Access Compliance Report

Public Rights-of-Way

(Pedestrian Signals)

Intersection ID: N/A	Main Street:	Cross Street: N/A	Location: N/A
ADA ID: 59254B30DE02	Signal Type: One Push Button-APS	Overall Compliance: No	Severity Score: BTN 1: N/A BTN 2: N/A No BTN: N/A
Codes/Mitigation Info/Possible Solution		Field Measurements/Component Compliance

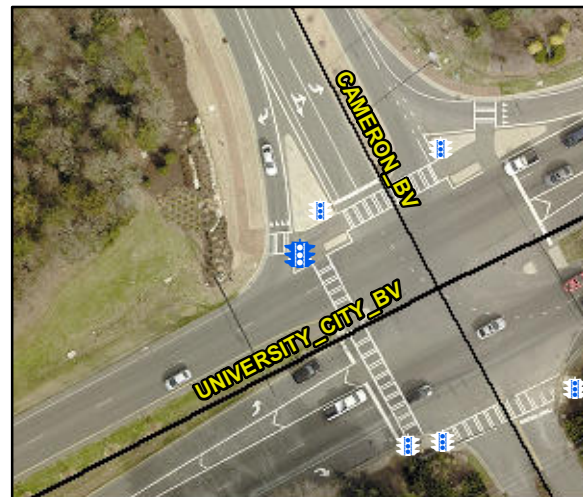
Possible Solutions: Provide PAR As Indicated. Remove and Replace Clear Space.

PROW/ADA: R404.3, R404.2, R404.7.3, R404.7.2
